BCA COMPLIANCE REPORT

BAY 4 & 5

1-3 HICKSON ROAD THE ROCKS

Report PR-425/2016-cl94

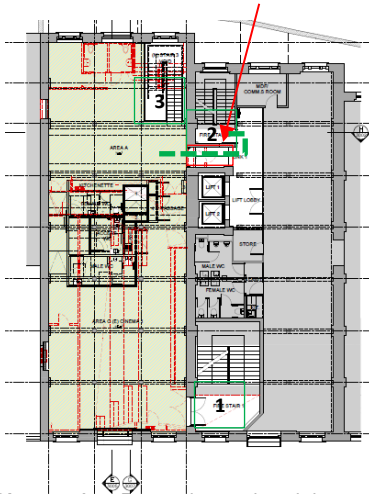
BCA REQUIREMENTS	Compatible with BCA YES/NO	COMMENTS
(ii) any openings protected internally in accordance with C3.4, for a distance of 3 m above or below, as appropriate, the level of the path of travel, or for the height of the wall, whichever is the lesser. (d) If more than 2 access doorways, not from a sanitary compartment or the like, open to a required fire-isolated exit in the same storey— (i) a smoke lobby in accordance with D2.6 must be provided; or (ii) the exit must be pressurised in accordance with AS/NZS 1668.1.		Stair 1 discharge  Ground floor level Bounding wall to be fire rated
D1.8 External stairways in lieu of fire-isolated exits	N/A	
D1.9 Travel by non-fire-isolated stairways or ramps	Yes	
D1.10 Discharge from exits	YES	
D1.11 Horizontal exits	Yes	Egress from Level 4 will require one of the required exits to comprise a horizontal exit i.e. Exit No. H1 refer to Diagram 11.

(a) Horizontal exits must not be counted as required exits— (i) between sole-occupancy units; or (ii) in a Class 9b building used as an early childhood centre, primary or secondary school. (b) In a Class 9a health-care building or Class 9c building, horizontal exits may be counted as required exits if the path of travel from a fire compartment leads by one or more horizontal exits directly into another fire compartment which has at least one required exit which is not a horizontal exit. (c) In cases other than in (b), horizontal exits must not comprise more than half of the required exits from any part of a storey divided by a fire wall. (d) Horizontal exits must have a clear area on the side of the fire wall to which occupants are evacuating, to accommodate the total number of persons (calculated under D1.13) served by the horizontal exit of not less than— (i) 2.5 m^2 per patient/resident in a Class 9a health-care building or Class 9c building; and (ii) 0.5 m^2 per person in any other case. (e) Where a fire compartment is provided with only two exits, and one of those exits is a horizontal exit, the clear area required by (d) is to be of a size that accommodates all the occupants from the fire compartment being evacuated. (f) The clear area required by (d) must be connected to the horizontal exit by an unobstructed path that has at least the dimensions required for the horizontal exit and may include the area of the unobstructed path.		Path of travel from within Bay 4 must be maintained accessible for occupants within Bay 5.  Diagram 11 – Horizontal exit Level 4 In order for the horizontal exit provisions to be applied in respect of exit H1, the bounding wall between Bay 4 & 5 will have to be considered a fire wall. As such the wall is required to achieve an FRL of at least 120/120/120 and any opening in such wall to comprise a minimum FRL of -/120/30. It is further noted that: - Exit H1 will only comprise 1 of the 2 exits required to serve level 4; - The area within Bay 4 is sufficient to accommodate the deemed population of Bay 5-Level 4 which is less than 30.

BCA REQUIREMENTS	Compatible with BCA YES/NO	COMMENTS
		On the basis that the openings within the bounding wall between Bay 4 & 5 achieves the required FRL and the openings are fitted with the required fire doors the requirements of D1.11 are considered capable of being satisfied. It should be noted however that the path of travel from within Bay 4 (opposite H1) will need to enable a clear path of travel to Stair 2 & 5. As the tenancy within Bay 4 may not be the same tenancy as Bay 5, consideration will need to be given in terms of how access to the available exists (is Stair 2 & 5) is provided from within Bay 4 and thereafter, maintained.
<u>D1.12 Non-required stairways, ramps or escalators</u>	Yes	Stair 3 is considered to be a non-required stair that connects ground floor and Level 1 only.
<u>D1.13 Number of persons accommodated</u> Commercial use occupancy is determined as follows. Class 5 1 person/10m ²	For Notation	The deemed population associated with a Class 5 use in respect of Bay 5 is determined on the basis of 1 person / m ² of floor area. The floor area per floor excluding the central amenities core and Stair 3/4 is approximately 220m ² . This equates to a deemed population of approximately 22.

Diagram 17 – Typical amenities core incorporating access ramp

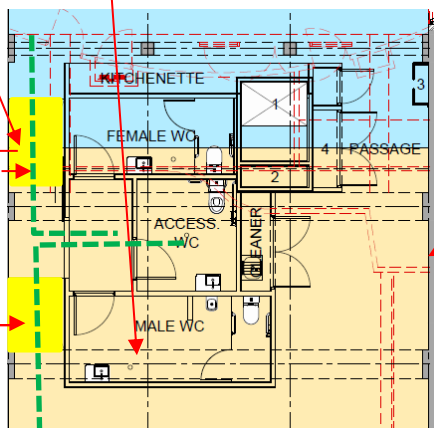
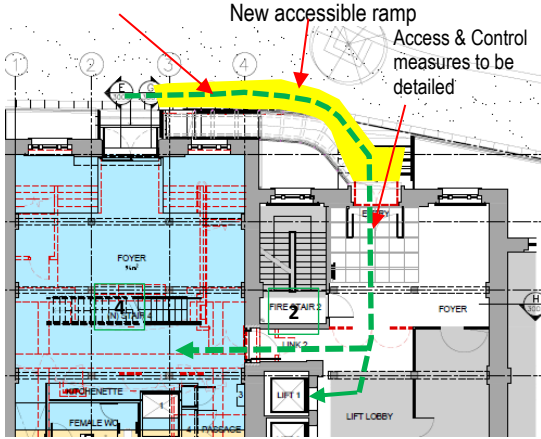
Circulation areas are required to comply with AS1428.1-2009 ramp grades to be identified. If steeper than 1:20 they are deemed ramps and must have handrails, kerb rails, tactile and the like incorporated. If 1:20 then they are deemed walkways and accessible features such as handrails etc. does not apply.
